Product Change Notice (PCN)

PCN Number: PCN-0334199R-01

Product(s) Affected: CMM-4030DT-26164-TR

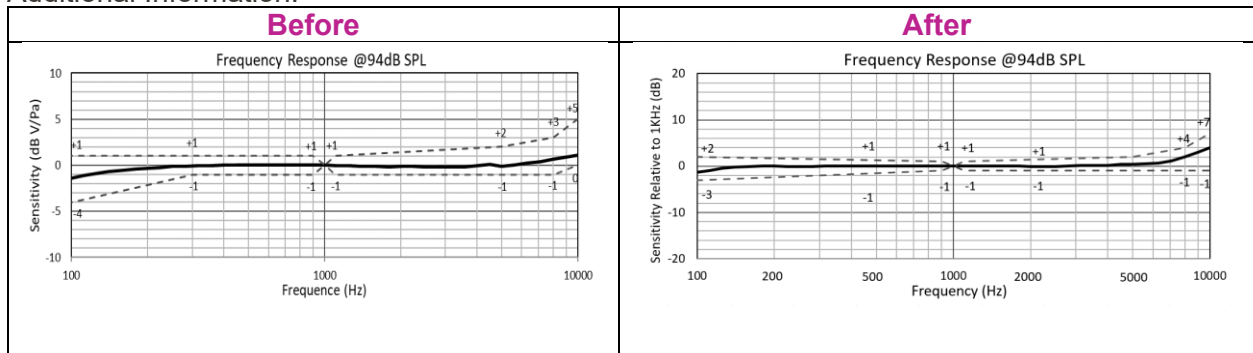
Reason(s) for Change: Updated design and internal chip.

Description of Change: External color is lighter and the sound hole is now surrounded by a larger copper area. Standard performance mode has changed from a maximum of 4.0MHz to a maximum of 4.8MHz. Wake time maximum has been increased from 200µm to 20ms. Please see frequency graph comparison pictured in "Additional Information".
